Cedar City

CITY COUNCIL WORK MEETING
JULY 21, 2021
5:30 P.M.

**CEDAR CITY
CITY COUNCIL AGENDA ITEM 21
STAFF INFORMATION SHEET**

**LOW PROFILE
30" CURB & GUTTER
TYPE D**

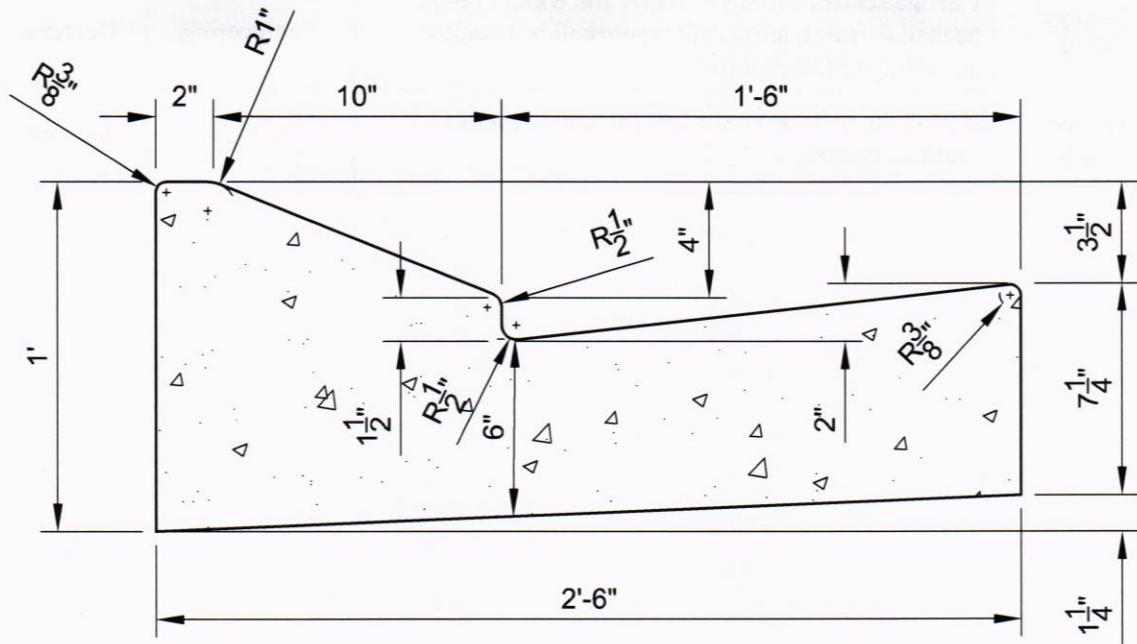
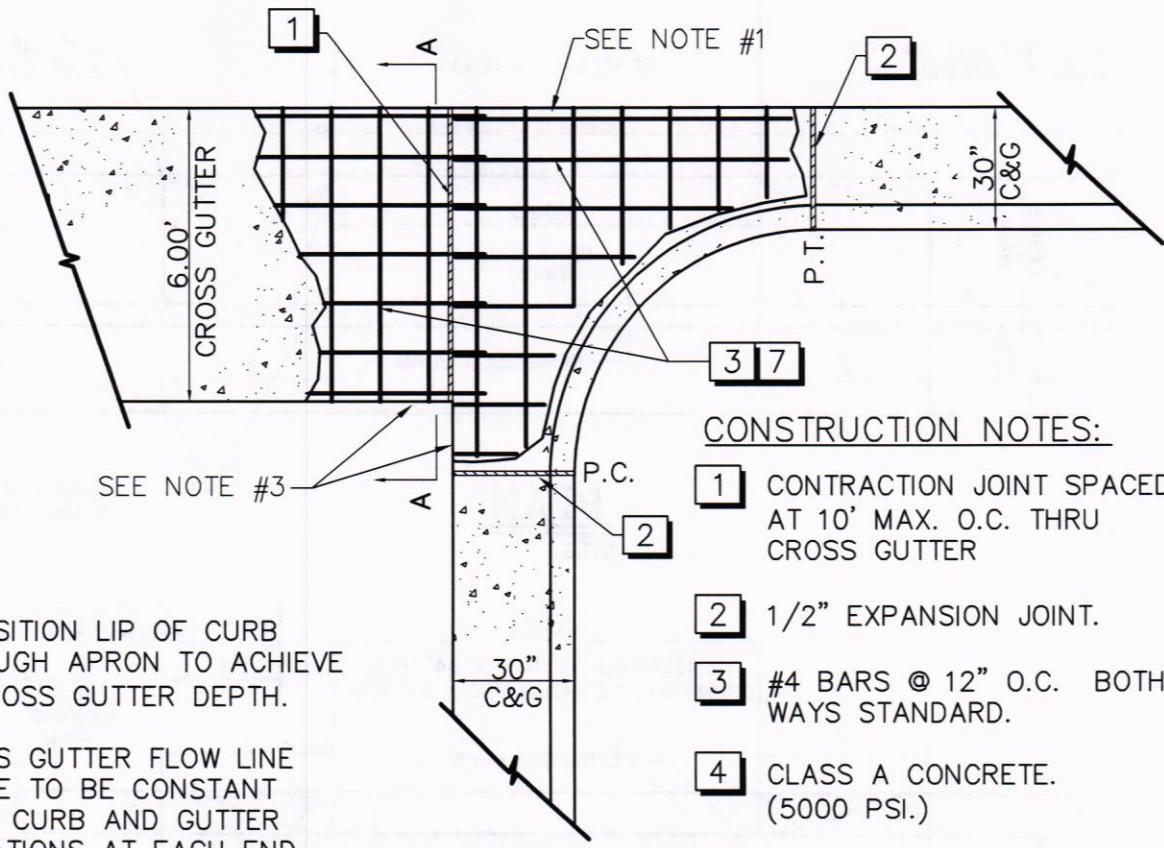
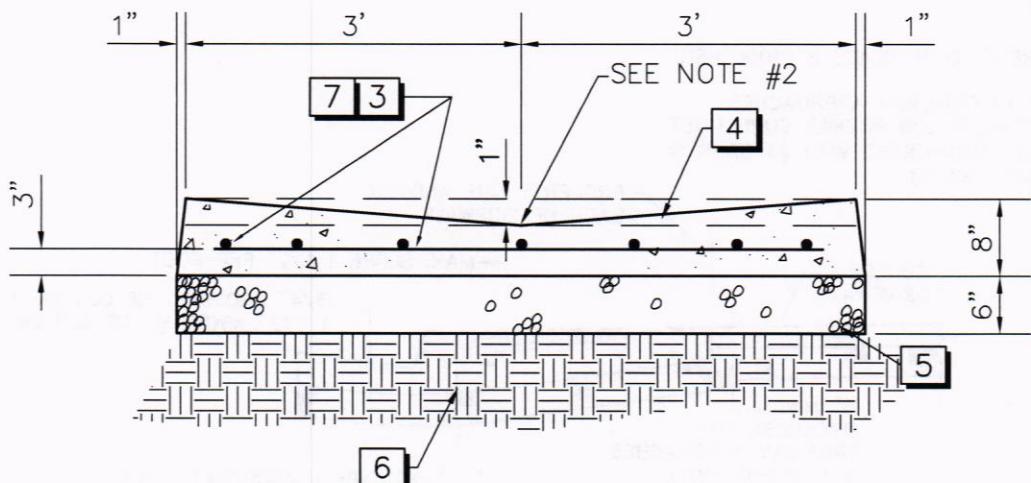
1. Low-profile curb & gutter: Detail C1A is being proposed to add as an option that will allow for a low-profile curb and gutter. This type of curb and gutter will allow for driveway to be installed at residences without cutting out the curb, gutter, and sidewalk.
2. 5' x 5' passing spaces: Detail C6 is proposed to be modified to require a 5-foot by 5-foot passing space on City sidewalks. This will bring the City into compliance with ADA requirements that call out a passing zone at 200-foot intervals.
3. Flowable fill deleted: The flowable fill requirement is proposed to be deleted on Detail R1. It is proposed to return to regular backfill in the pipe zone on larger pipe sizes.

Item #	Section/ Drawing Sheet	Description	Requested or Recommended By:	Cost Change
1	All Details	Added a "Revisions" table in the title block on all detail drawings.	Engineering	No change
2	Detail C1A	A new detail is being added for a 30-inch Type D "Low-profile Curb and Gutter." The Type D low-profile curb and gutter will only be allowed on Local (45') wide streets in R-1, R-2-1, R-2-2, and R-3-1 residential zones. The sidewalk behind a Type D low-profile curb and gutter will remain as 4 inches thick, except at driveway approaches where the required sidewalk thickness will be 6 inches thick with reinforcement.	Public	Decrease
3	Detail C2	<p>Note added stating that the minimum flowline grade through a cross-gutter is 0.5% minimum slope. In talking to concrete contractors, it is difficult to hand work a cross-gutter at a flatter slope than 0.5%.</p> <p>Deleted the requirement for steel rebar chairs.</p> <p>Note added to clarify that 5,000 psi mix Class A concrete is required for cross-gutters.</p>	Engineering	No change

Detail C-1A: is a new detail about low profile curb called also mountable curb. The 30" matches the width of the current detail. The advantage is that you can drive over this curb. These are standards that could be used on City subdivisions. These don't necessarily only apply to the PUD but can also be used in any PUD. The advantage is that the drive approach would not need to be cut out at each home. The developer and builders have been asking for this and he feels it is a good option. If they want to use the standard high back curb, they are also welcomed to do that; this is just another option. He looked at this one as it is drivable. That sidewalk right behind that approach would need to be thickened so would be 6" reinforced next to that drive. The rest would not need to be reinforced only the drive approach area. this can be done at development, or if they choose, leave this for each homeowner. He is proposing to allow this on the typical 45' wide streets in all residential areas. Then they get into the R-3-M zone, this is not a good choice as they are spaced to not that good of an advantage. They will discourage those, so they don't pull over the sidewalk to park.

SHEET NO.
C4
FILE
CO4

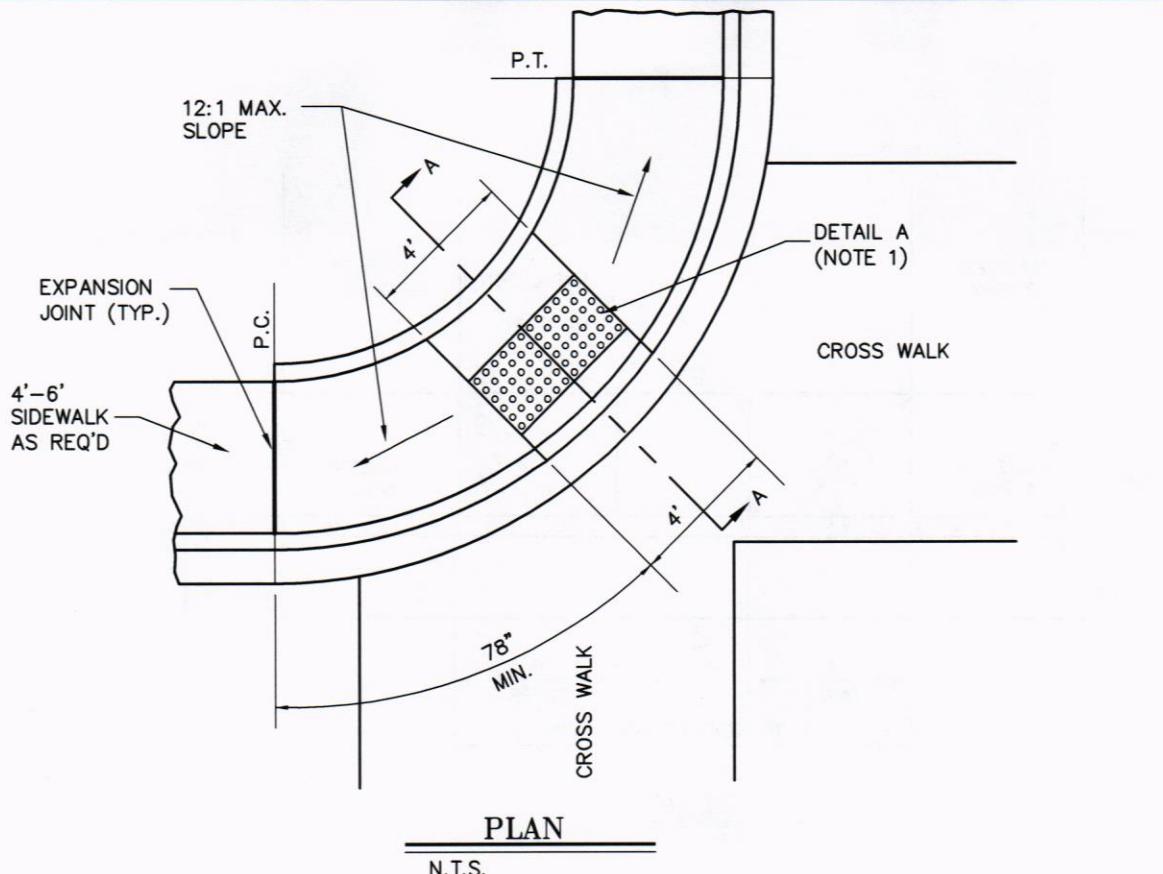
Detail C4- clarify area between drive, 4' between.

SHEET NO.		EARTH FILLED TRENCH SECTION		DATE 7/2021		DATE 7/2021	
R1				REVISIONS		REVISIONS	
PAGE R01				DATE 7/2021 REMOVED FLAMMABLE FILL, ADDED NOTES 5 & 6		DATE 7/2021 N.T.S.	
				BY J.A.S.		BY T.B.M.	
				10 NORTHEAST CEDAR CITY UTAH 84720 PH. (435) 548-2043		DRAWN T.B.M.	
						CHECKED J.A.S.

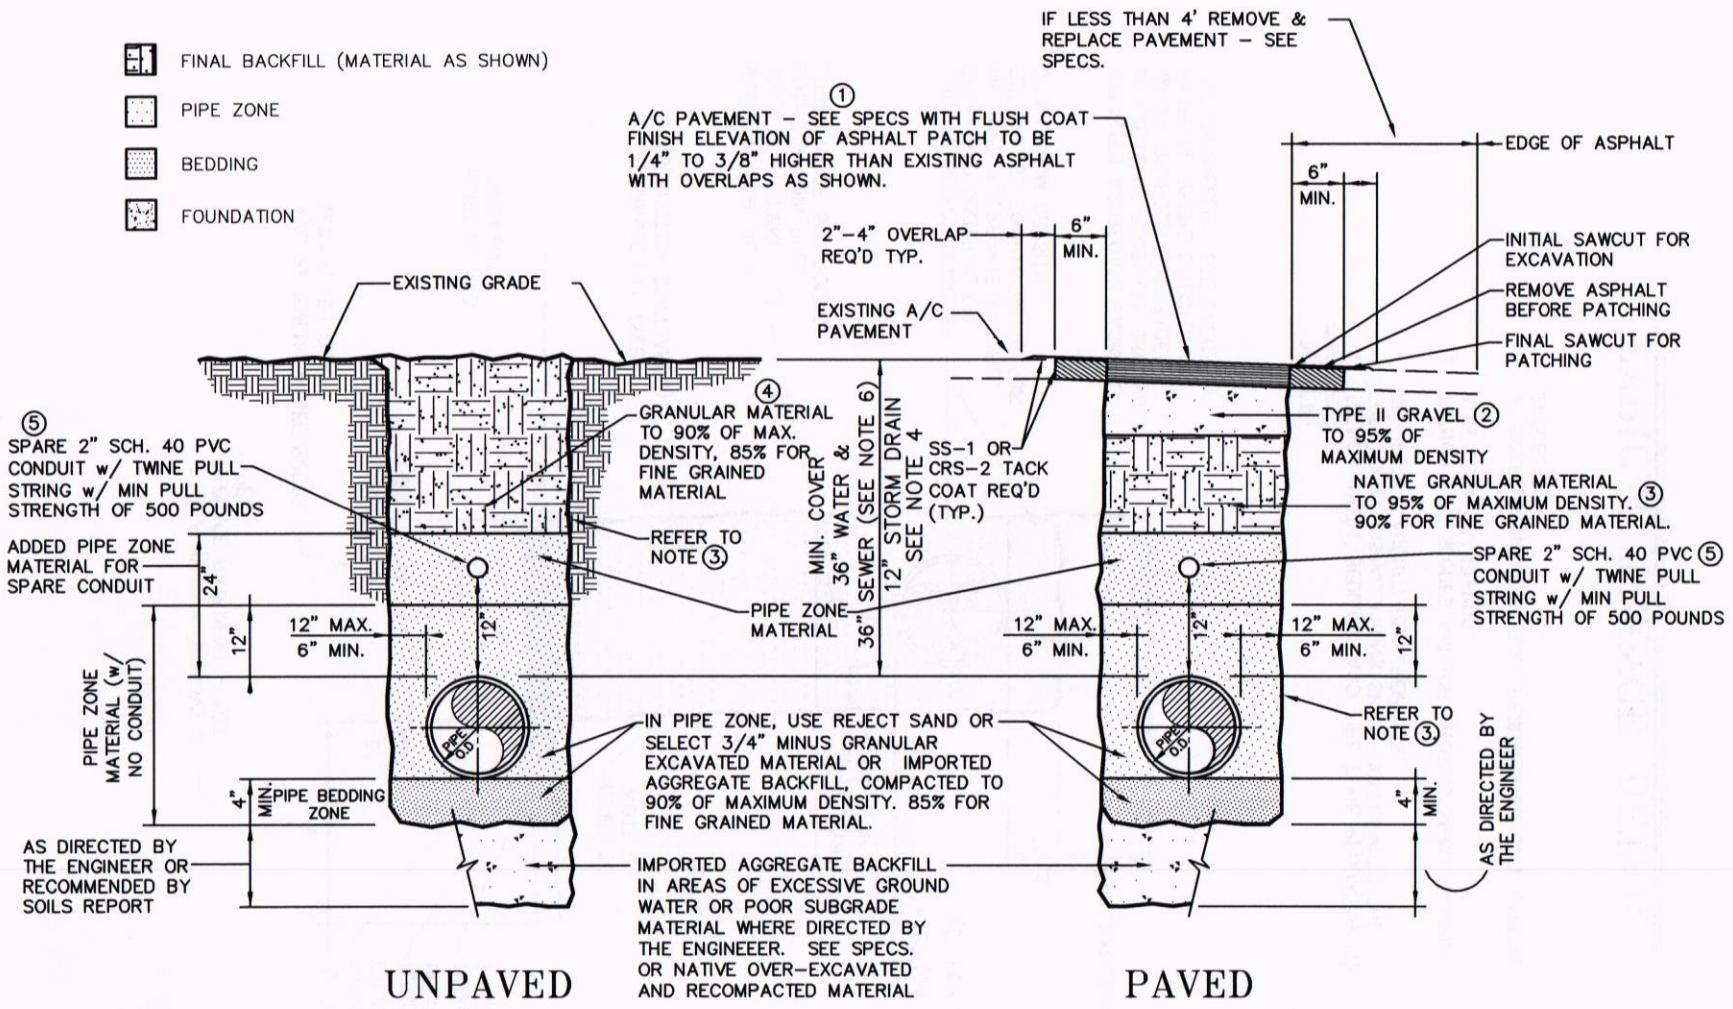
9	Details LS1 and LS2	Note added regarding tree pruning for trees near an asphalt trail. This detail is added for City maintenance of trails.	Engineering	Increase (City)
10	Detail R1	The flowable fill requirement in the pipe zone has been removed from this detail.	Public	Decrease
		Note added to clarify that the 2-inch spare conduit is only required on City capital projects.	Engineering	No change
		Note added stating that 2-inch spare conduits must terminate in a junction box located outside the roadway.	Engineering	Increase (City)
		Note added stating that minimum sewer manhole depth is 48 inches to top of pipe.	Engineering	Increase
		Note added to clarify that trench side-slopes shall comply with OSHA standards.	Engineering	No change
11	Detail R2	Note added to clarify that trench side-slopes shall comply with OSHA standards. Note added stating that the 2-inch spare conduit is only required on City capital projects.	Engineering	No change

Detail R-1: is the standard trench. This is a major change; they currently require flowable fill in the pipe zone for pipe larger than 12" diameter. The concern of contractors is #1, the cost, and also it fills up the pipes. They are proposing to remove that and go back to the standard trench backfill. They will clarify 2" conduit shown and clarify that is only required on City projects. Also, a note of the minimum sewer manhole depth of 48" to the top of pipe. In order to get a manhole depth that is useable, that needs to be 48" in the valley and some are typically 9' and the City does allow less than that in certain circumstances, but they will require that to be 48" to the top of pipe.

Detail R-1: is the standard trench. This is a major change; they currently require flowable fill in the pipe zone for pipe larger than 12" diameter. The concern of contractors is #1, the cost, and also it fills up the pipes. They are proposing to remove that and go back to the standard trench backfill. They will clarify 2" conduit shown and clarify that is only required on City projects. Also, a note of the minimum sewer manhole depth of 48" to the top of pipe. In order to get a manhole depth that is useable, that needs to be 48" in the valley and some are typically 9' and the City does allow less than that in certain circumstances, but they will require that to be 48" to the top of pipe.

R3

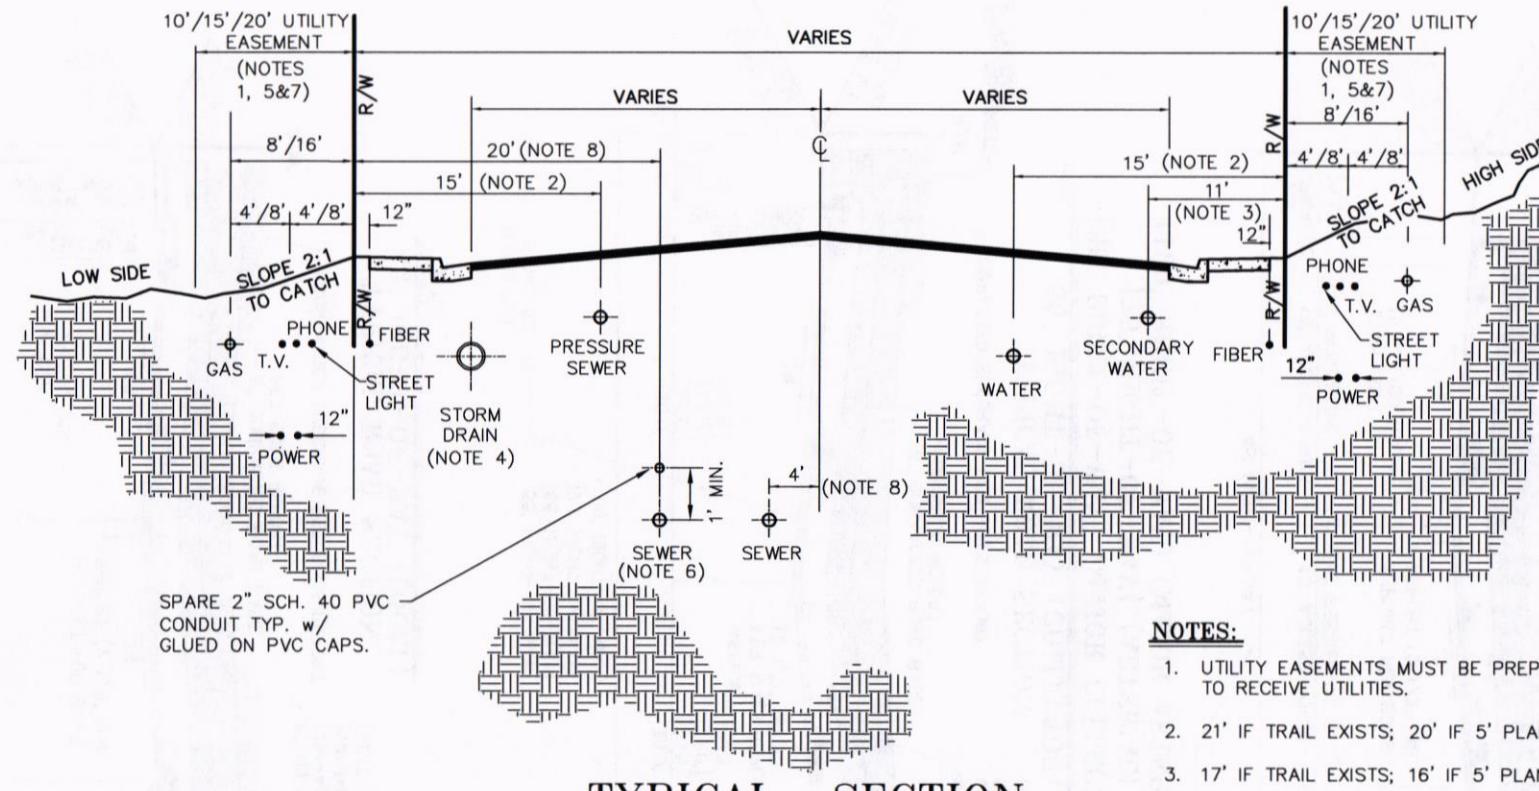
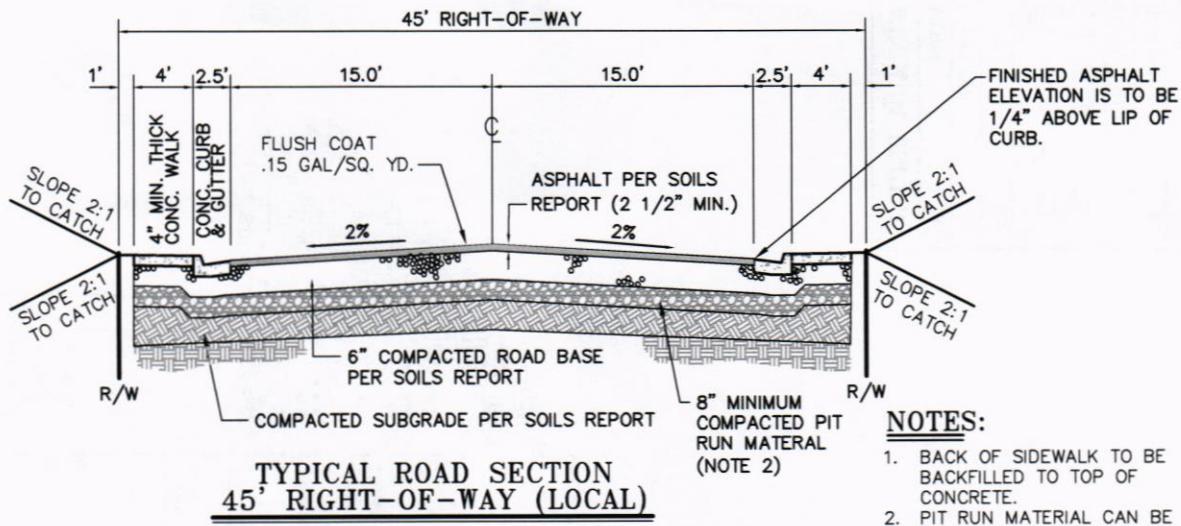
12	Detail R3	Note added to clarify that the 2-inch spare conduit is only required on City capital projects.	Engineering	No change
		Note added stating that 2-inch spare conduits must terminate in a junction box outside the roadway.	Engineering	Increase (City)
		Note added to clarify that the minimum separation between water and sewer lines is 10 feet.	Engineering	No change
		Deleted a note regarding preparing the utility easements that was redundant.	Engineering	No change

Detail R-3; shows locations for utilizes. Changed that in RE to 15'. Provide more room for water meter and fire hydrants.

REVISIONS		
DATE	DESCRIPTION	BY
7/2021	DETAIL R4D ADDED TO STANDARDS	J.A.S.

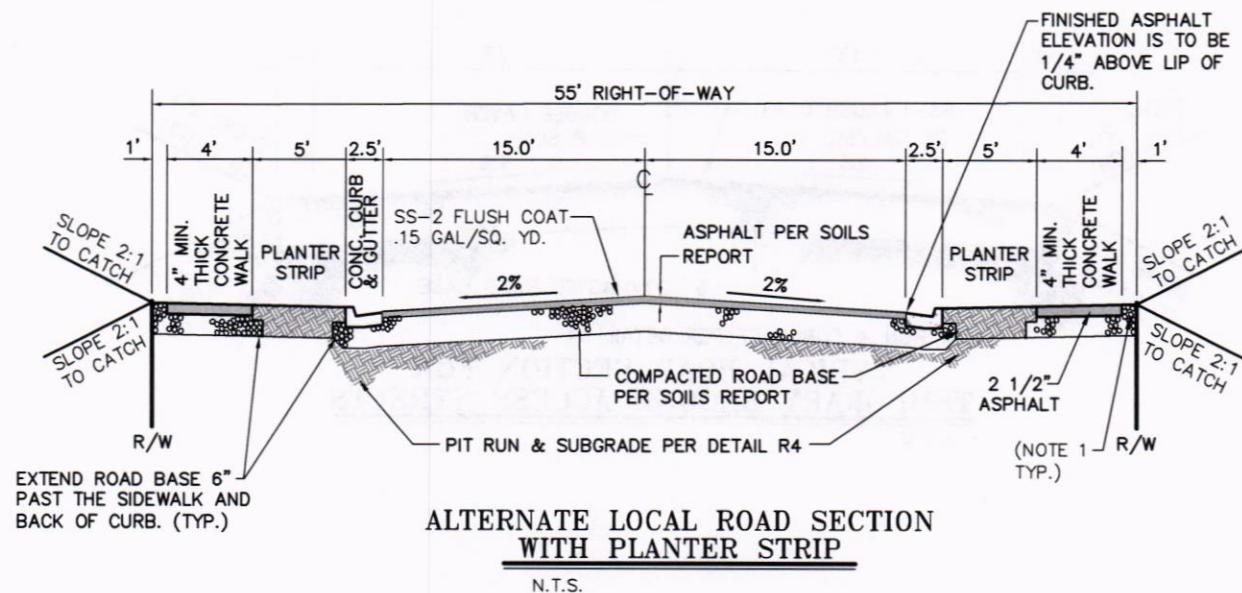
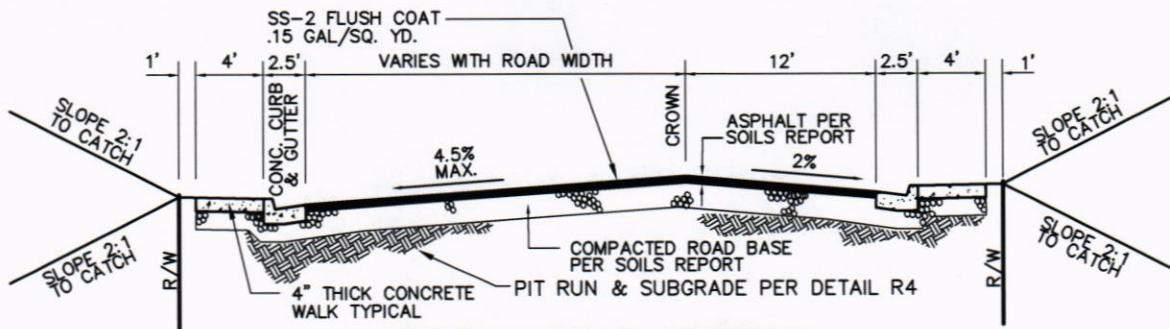
5. Road Section with Planter Strips: Detail R4D is being proposed as an option for a local road section with planter strips. The planter strips would increase the right-of-way width from 45 feet to 55 feet.

Detail R4D- is a new detail for roads with planter strip. It was discussed in Project Review last week; there were lots of questions. This would be an option in a subdivision instead of 45' wide road, they would go to 55' wide with a 5' planter strip on each side. the City has none currently. Jonathan said the main questions were what type of shrubs, trees, etc. what root barrier needed, so the roots don't take up the sidewalk. then the question of who fixes all this. Usually, it is the City. If they do a planter strip, they would like to minimize those problems.
